CITY OF ALLENTOWN

RESOLUTION

R4 – 2022

Certificates of Appropriateness for work in the Historic Districts:

Property located at: 443 N 9th St.
Agenda Item: #2.a
Historic District: Old Allentown
Case: HDC-2021-00033
Meeting date: December 6, 2021

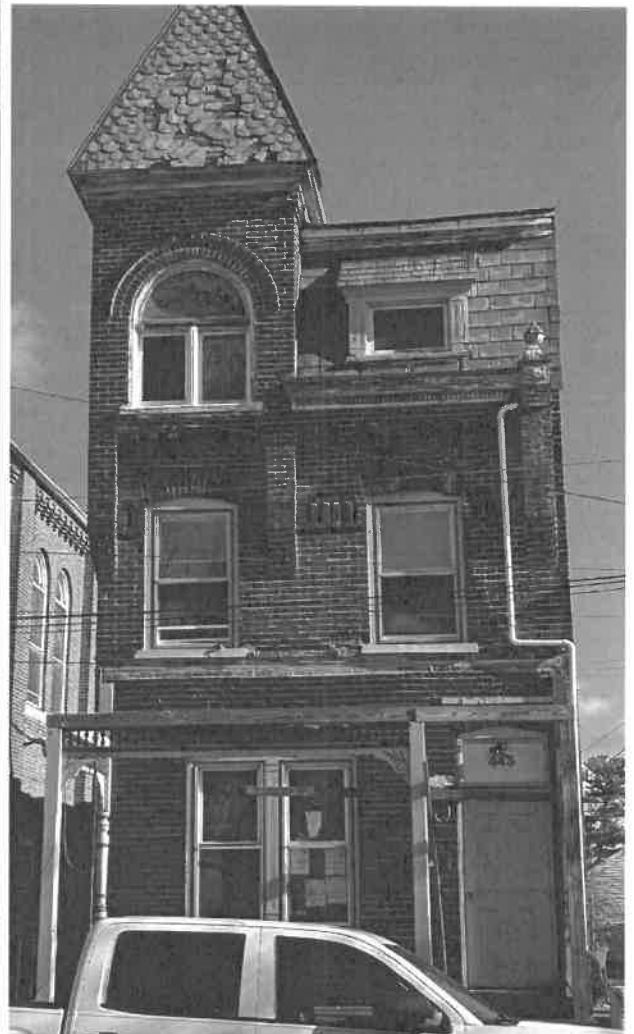
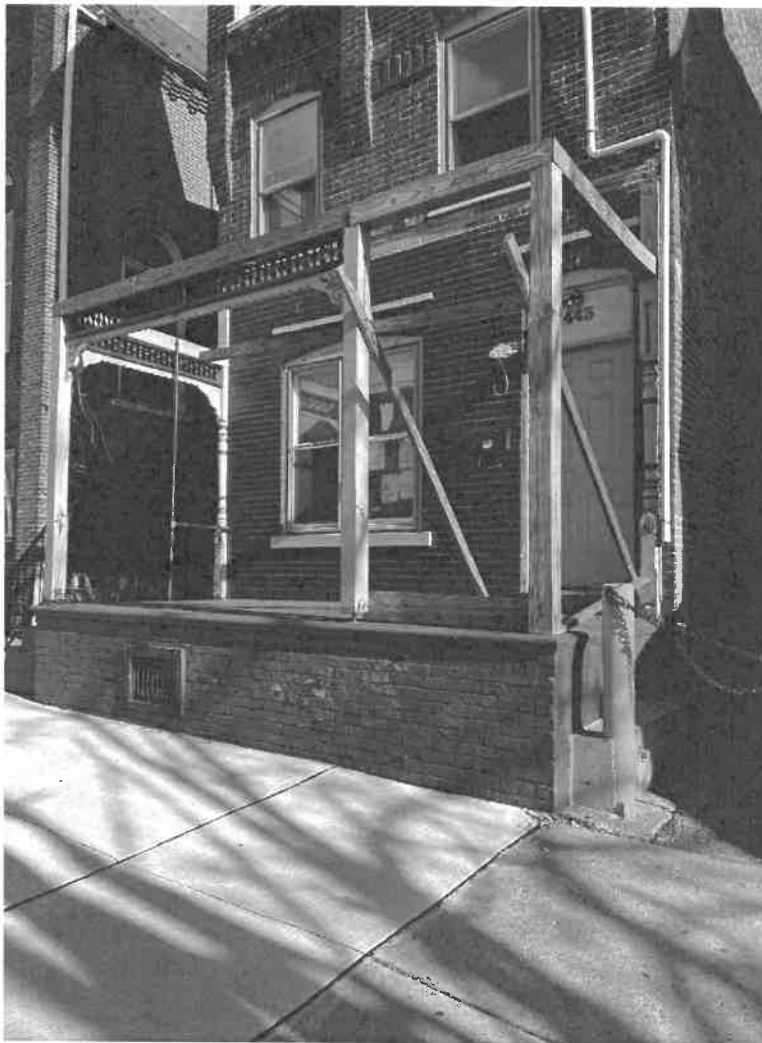
The proposed substitute material of synthetic slate (EcoStar Majestic Slate with bevel edge) is appropriate. Use of “rubber simulated slate shingles” is allowed by the Guidelines. The proposed product will be consistent with the existing turret roof slate shingles in size, dimension, profile, shape, configuration, thickness, and appearance. The mansard roof shingles are rectangular in shape and profile; rectangular synthetic slate would be a more appropriate replacement. However, it is generally historically appropriate for slate shingles to match across a building’s different roof slopes and replacement of this roof was previously approved.

The proposed substitute of 3-tab shingles for the porch roof will result in minimal visual impact to the building. The proposed product is a dark color and rectangular in shape. Architectural shingles with even exposures and rectangular cuts are generally recommended over 3-tab shingles as a higher quality material; however, the applicant has demonstrated that the approved shingle product is not currently available due to material shortages and manufacturing interruptions.

The proposed materials appear to be appropriate substitutes. It is recommended that the HARB discuss with the applicant the shape of the mansard roof shingles. For the 3-tab shingles substitute for architectural shingles, it is recommended that the HARB consider citing that due to ongoing supply chain issues and material shortages caused by the ongoing Covid-19 pandemic, there is a lack of normally acceptable alternative materials, and that they make the approval without creating precedent.

HARB members agree that the change to EcoStar material is an improvement and that the asphalt shingle was likely on the porch prior to its removal and is therefore a like-for-like replacement and therefore appropriate.

A motion to approve the application as presented with the condition that this proposal and subsequent approval does not impact the previous COA was made by HARB member Glenn Lichtenwalner, motion was seconded by HARB chair David Huber. Motion carried with unanimous support.
